**URGENT FIELD SAFETY NOTICE
 MEDICAL DEVICE CORRECTION
 FSCAs 2249723-06/02/2023-010-C, 2249723-06/02/2023-011-C,
 2249723-06/02/2023-013-C & 2249723-06/02/2023-014-C
 Datascope Cardiosave Hybrid and Rescue Intra-Aortic Balloon Pumps (IABP)**

Product Description:	Product Code/Part Number:	UDI Code:
Cardiosave Hybrid	0998-00-0800-31 0998-UC-0800-31	10607567109053 N/A
Cardiosave Hybrid	0998-00-0800-32	10607567111117
Cardiosave Hybrid	0998-00-0800-33 0998-UC-0800-33	10607567109008 N/A
Cardiosave Hybrid	0998-00-0800-34	10607567111940
Cardiosave Hybrid	0998-00-0800-35	10607567109107
Cardiosave Hybrid	0998-00-0800-45	10607567108421
Cardiosave Hybrid	0998-00-0800-52 0998-UC-0800-52	10607567108438 N/A
Cardiosave Hybrid	0998-00-0800-53 0998-UC-0800-53	10607567108391 N/A
Cardiosave Hybrid	0998-00-0800-55 0998-UC-0800-55	10607567108414 N/A
Cardiosave Hybrid	0998-00-0800-65	10607567113432
Cardiosave Rescue	0998-00-0800-75	10607567112312
Cardiosave Rescue	0998-00-0800-83	10607567108407
Cardiosave Rescue	0998-00-0800-85	10607567113449

Figure 2-5: Grasping the Fiber-Optic sensor connector

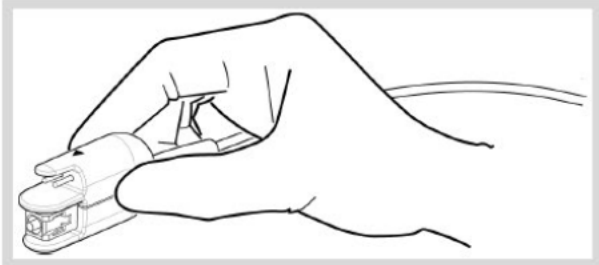
The Fiber Optic connector is designed to fit smoothly into the IAB Sensor Input. The red triangle on the top of the connector should align with the red triangle on the Cardiosave console. Inserting the Fiber Optic connector into the port without verifying the correct alignment can lead to internal damage. If difficulty is encountered when inserting the connector, verify that the connector is in the correct position and attempt to reinsert into the IAB Sensor Input.

Excessive force can cause damage to the connector and the internal fiber optic assembly of the IABP console. This may cause a disruption in the fiber optic signal acquisition resulting in an inability to acquire a fiber optic signal on the Cardiosave IABP. Following proper insertion procedures will minimize the potential for damage to the connector and a loss of signal. This conclusion is based on field observations seen through the complaints evaluation. As part of Datascope's investigation testing will be performed to confirm this observation.

In step 4, when the Fiber-Optic connector is inserted into the IAB Sensor input until an audible "click" is confirmed, ensure that you are not using excessive force as that can lead to damage to the Cardiosave.

1. With one hand, grasp the Fiber-Optic Sensor Connector as shown in Grasping the Fiber-Optic sensor connector, with the red triangle visible on top.

2. Remove and discard the protective cover from the Fiber-Optic IAB connector. Do not touch the exposed end of the Fiber-Optic cable.
3. With the other hand, open the protective shutter that covers the opening for the IAB Sensor Input (item 11, section 1.5.1) by rotating it to the left.
4. Insert the Fiber-Optic IAB connector into the IAB Sensor Input until it "clicks".

Note:
Ensure that the red triangles on the Fiber-Optic IAB Sensor Connector and on the back panel are in alignment.
